Product Support Bulletin 2005-014

Maintenance of Way ~ Work Equipment Bulletin

SUBJECT: Emergency Hammer Lift Kit - 660120

MACHINE MODEL(S): Small Spiker Model SS-B

Figure 1

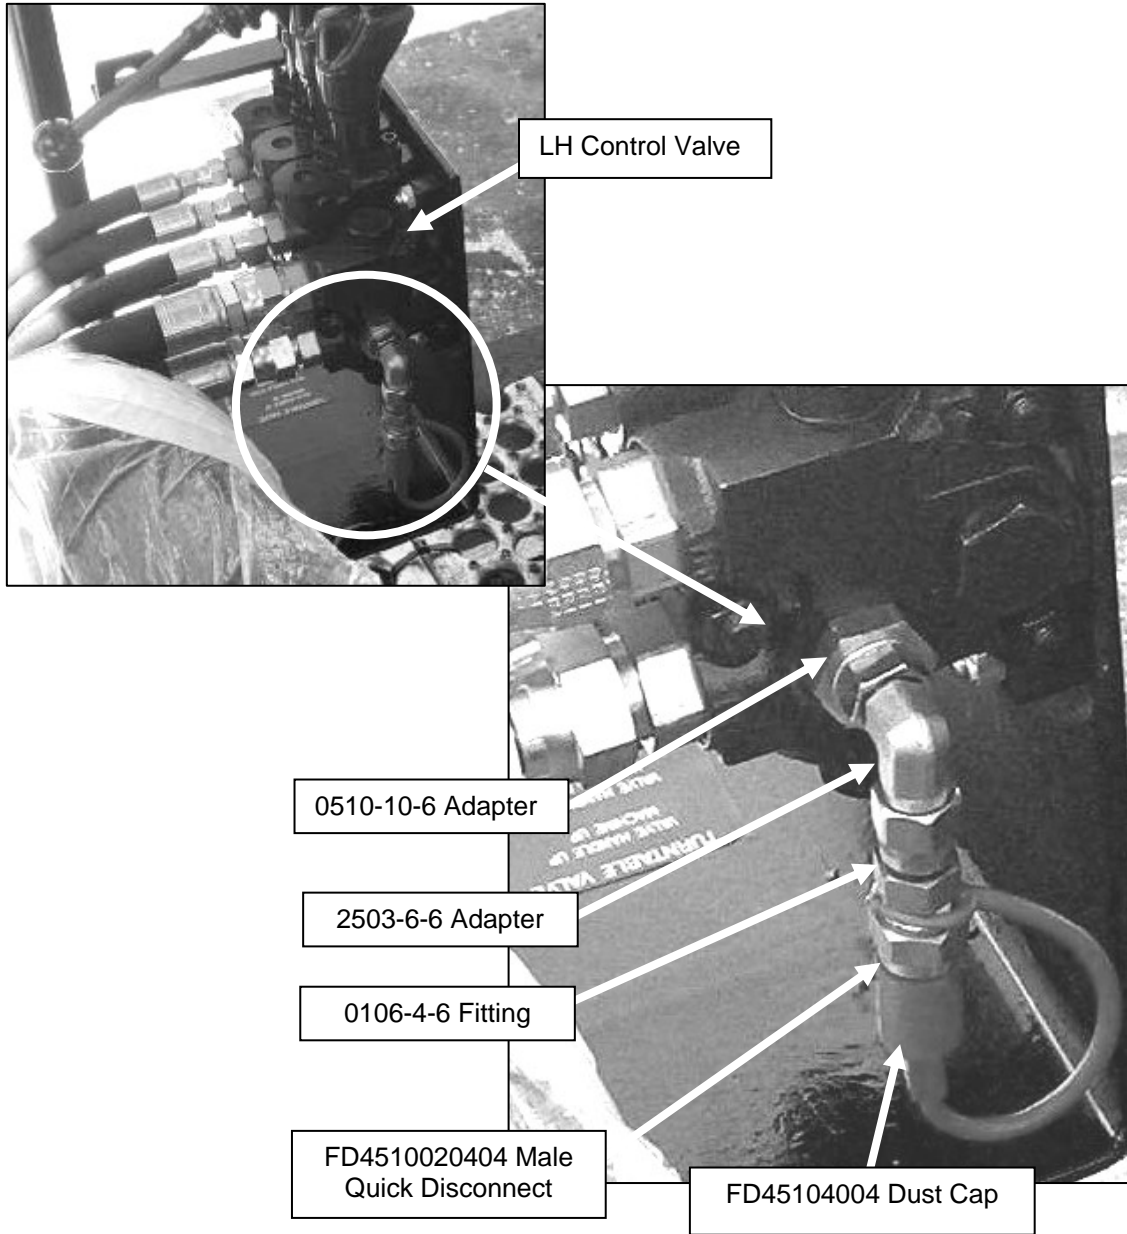
SUMMARY: The affected machines do not have a provision to raise the spike driving guns in the event of an engine or pump failure. Installing this kit will allow the spike driving guns to be raised with the emergency pump.

ACTION: The kit consists of a Quick Disconnect and 3 fittings that are installed in the pressure port of the left hand Gun Control Valve Bank. A plug is removed from the valve and the fittings installed in the valve bank. A Dust Cap for the quick disconnect is also included. See Figure 1.
